RE: ***Petition No. 1310A*** – Quinebaug Solar, LLC petition for a declaratory ruling, pursuant to Connecticut General Statutes §4-176 and §16-50k, for the proposed construction, maintenance and operation of a 50 megawatt AC solar photovoltaic electric generating facility on approximately 561 acres comprised of 29 separate and abutting privately-owned parcels located generally north of Wauregan Road in Canterbury and south of Rukstela Road and Allen Hill Road in Brooklyn, Connecticut. Reopening of this petition based on changed conditions pursuant to Connecticut General Statutes §4-181a(b)

**Petition No. 1310A**  
**Connecticut Siting Council Interrogatories**  
**Set One**

**Quinebaug Solar Study Area Comparison (2017 to present)  
Brooklyn/Canterbury, CT**

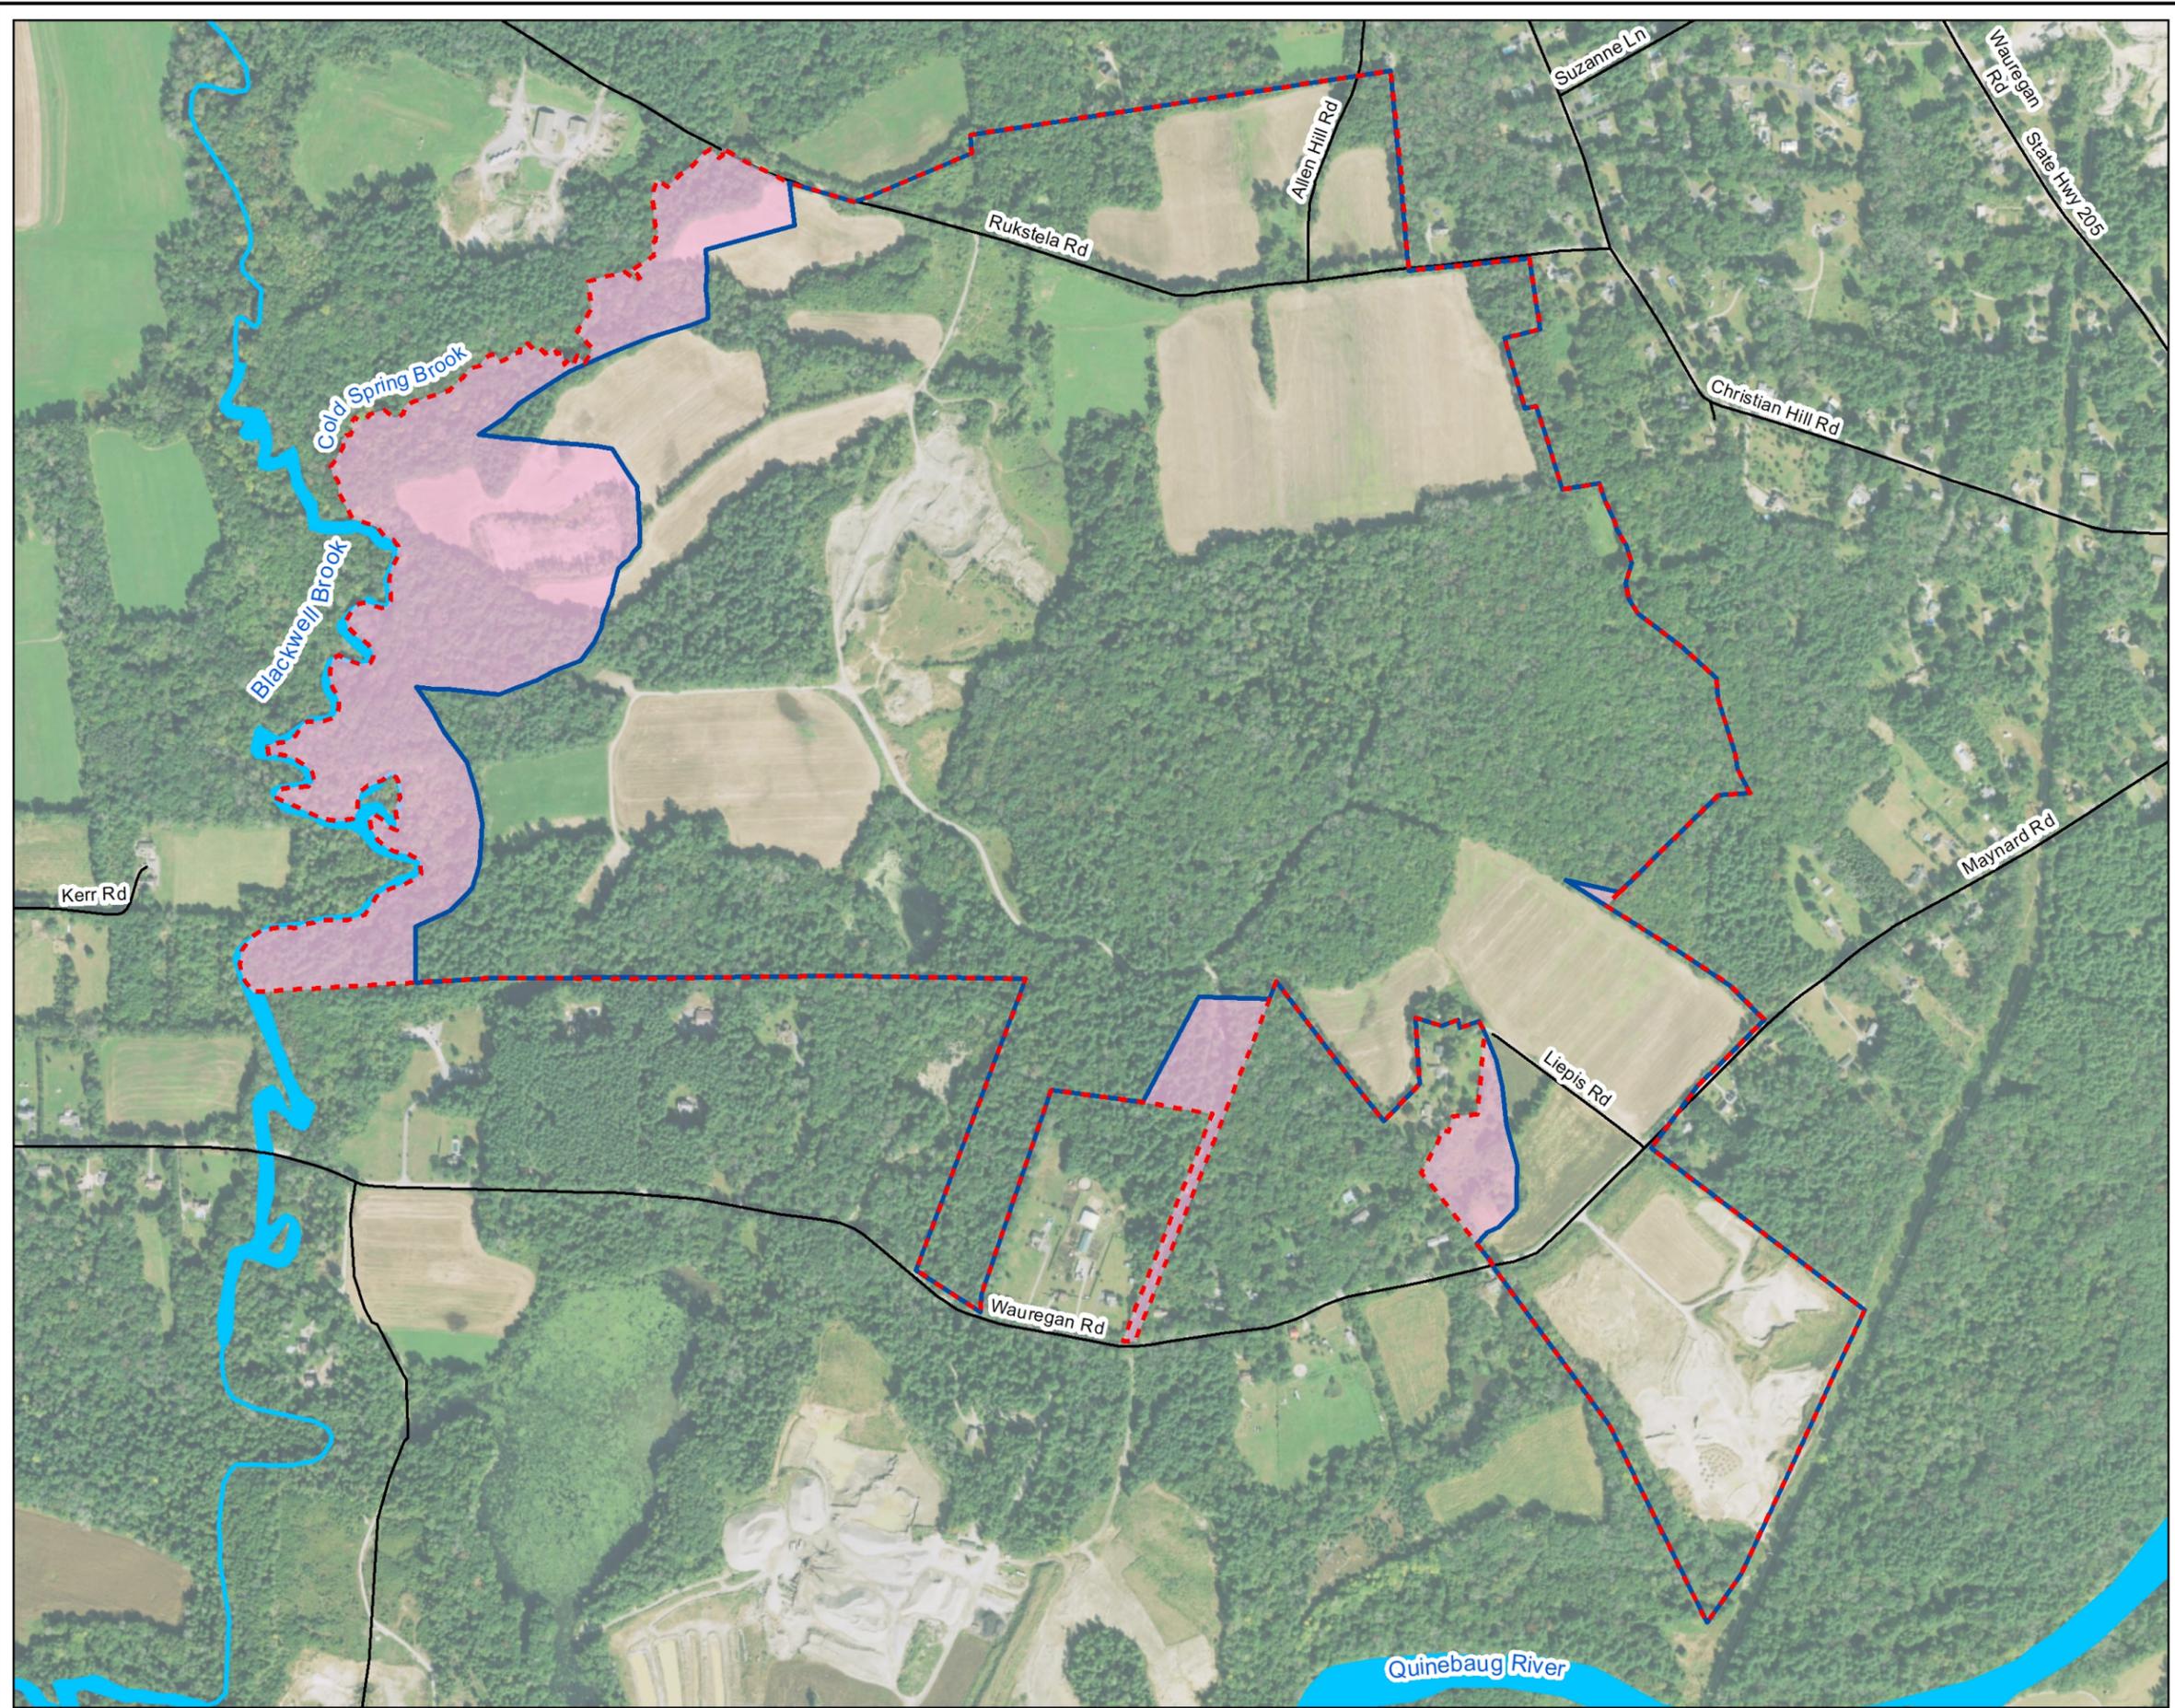
23. The Study Area now covers approximately 516 acres, an increase from the initial 451 acres. Beyond the increase due to Blackwell Brook and Cold Spring Brook, what areas were specifically added to the revised Study Area? Please provide a drawing indicating the Initial Study Area versus the Revised Study Area?

The expanded Study Area mostly consists of the area surrounding Blackwell Brook and Cold Spring Brook on the western side of the Project site. Additional Study Area is included in the central portion of the Project site to capture areas that were not included in the wetland delineation report from 2016. Increasing the Study Area has allowed the Project to more accurately account for and protect sensitive natural resources and wildlife habitat that occur adjacent to the proposed development area. *See Exhibit CSC-23 – Quinebaug Solar Study Area Comparison (2017 to Present).*

**Wetlands and Watercourse Buffers  
Quinebaug Solar Project  
Brooklyn/Canterbury, CT**

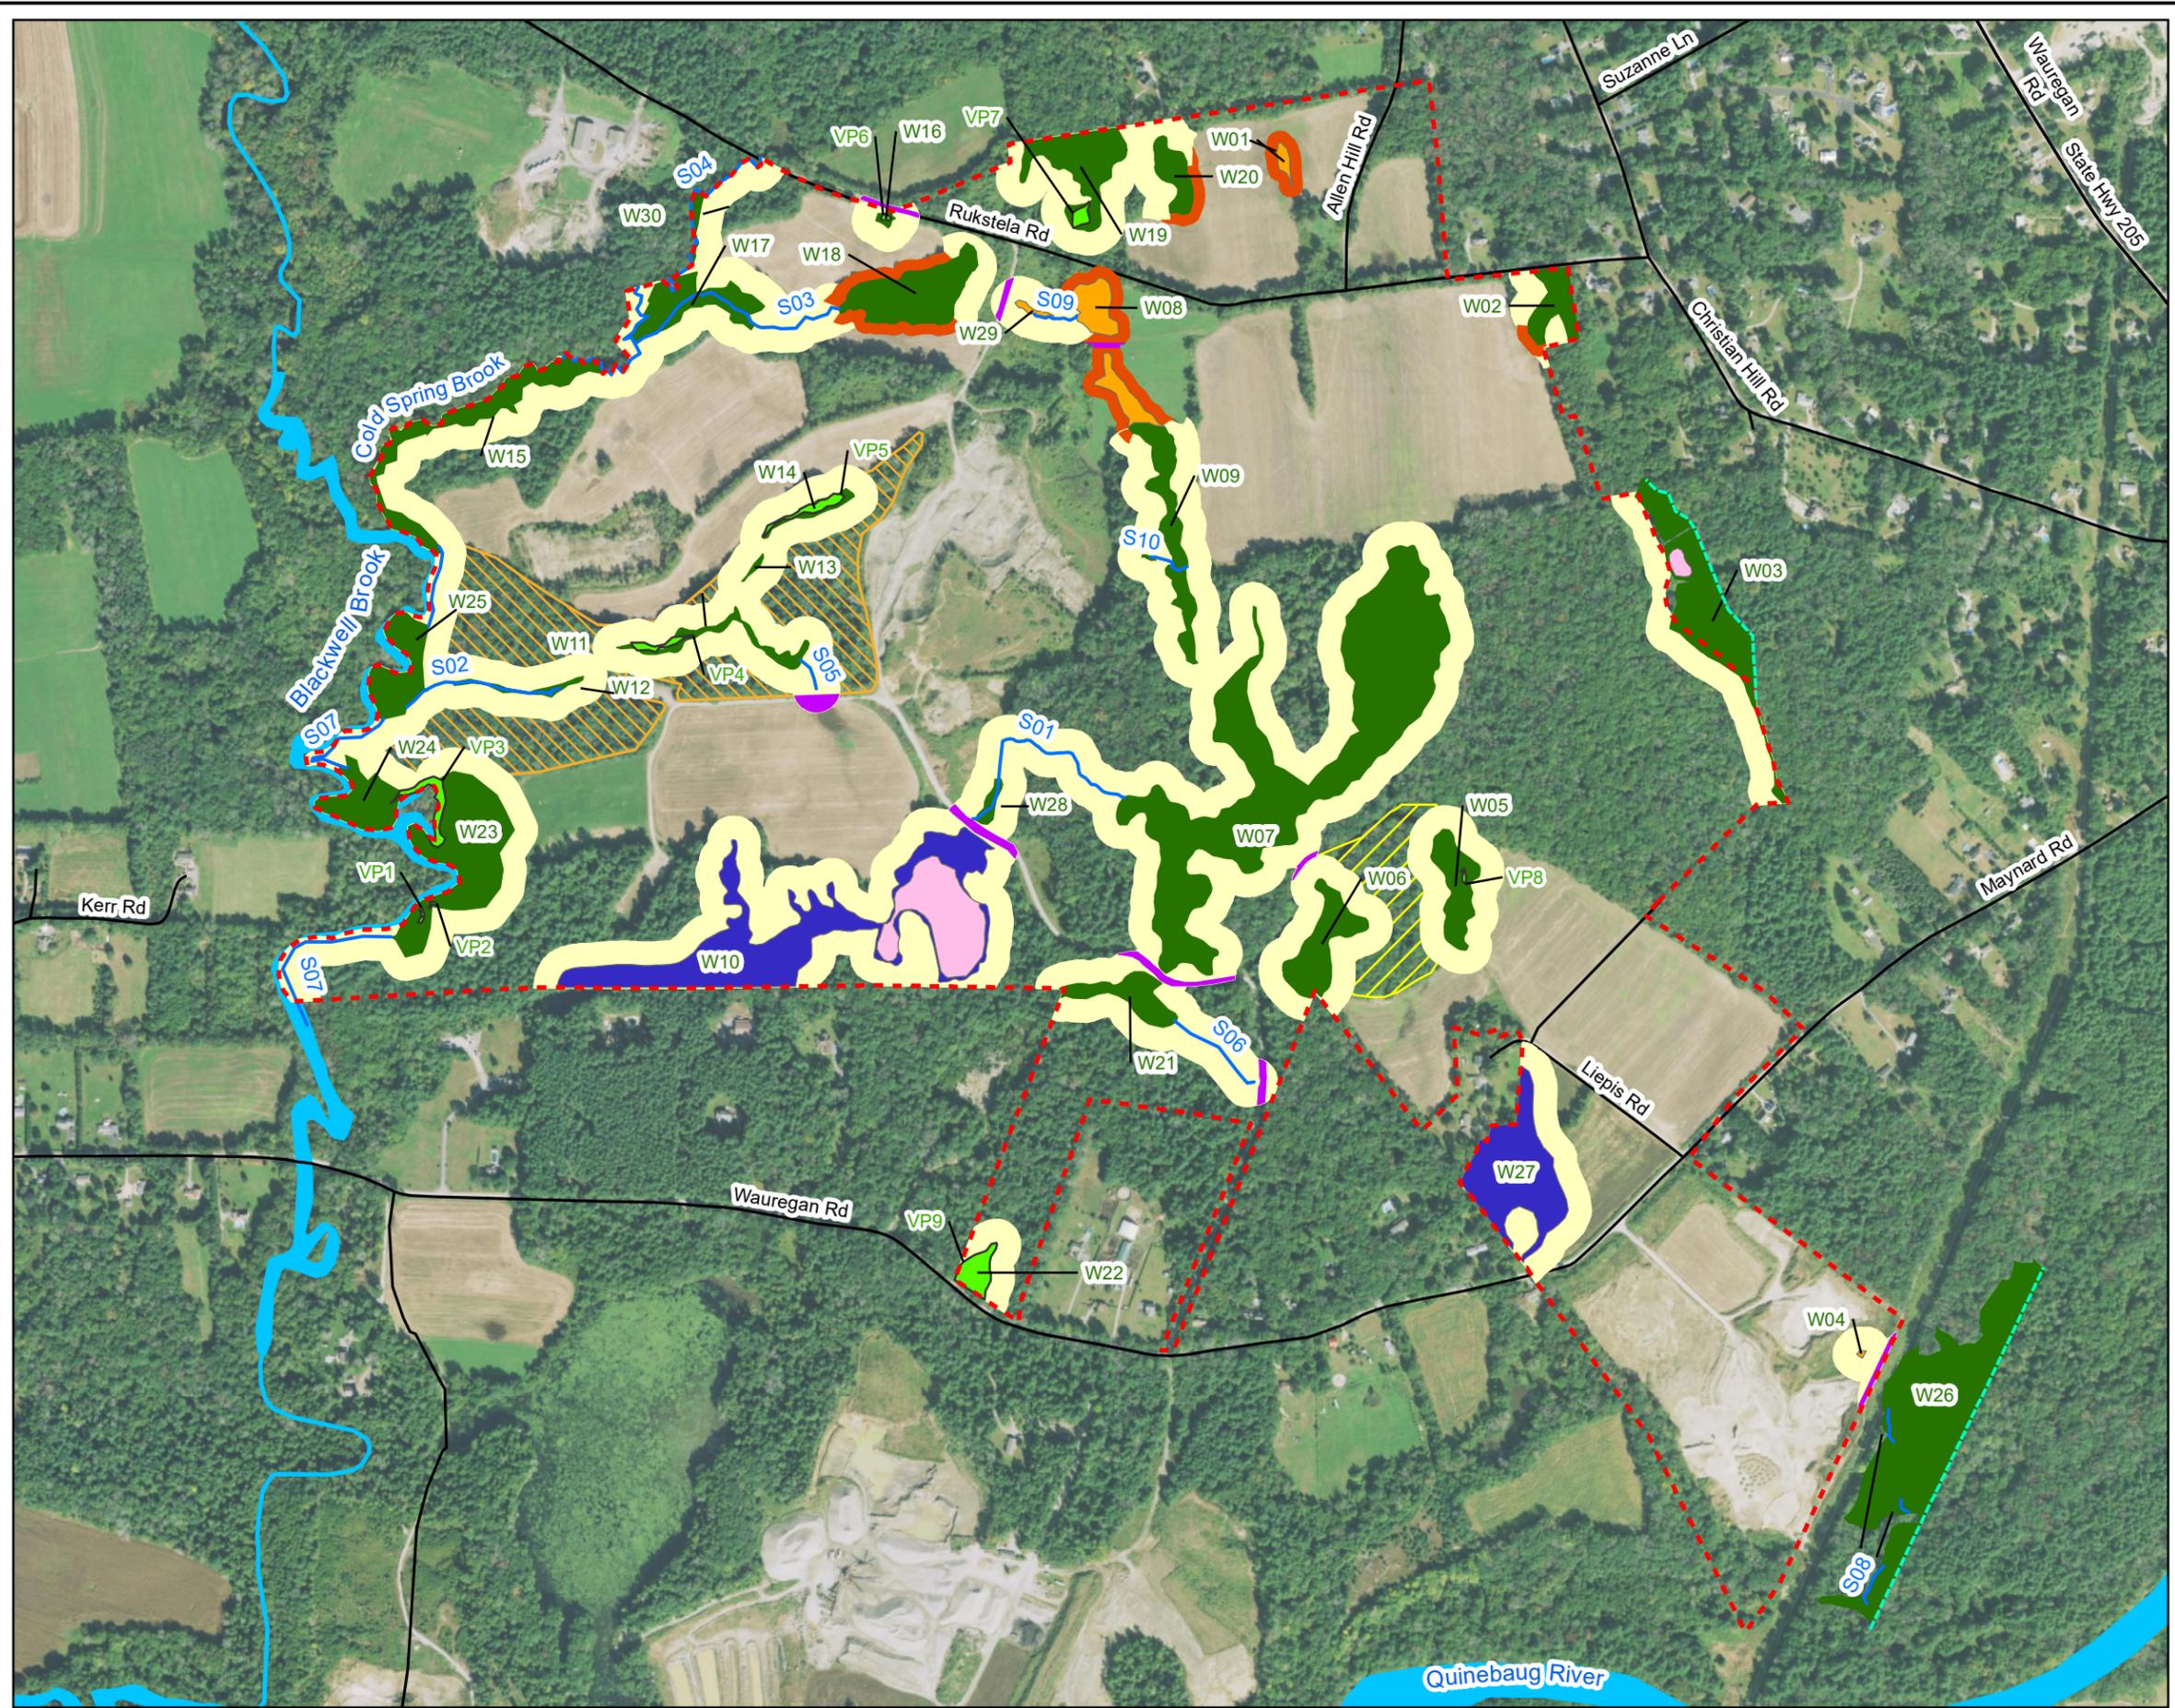
25. Referencing Figure 1 of the Pre-filed Testimony of Katelin Nickerson and Dr. Kevin Ryan, please provide a larger scale drawing, e.g. 11" x 17" of Figure 1.

See enclosed figure printed on 11x17 paper.
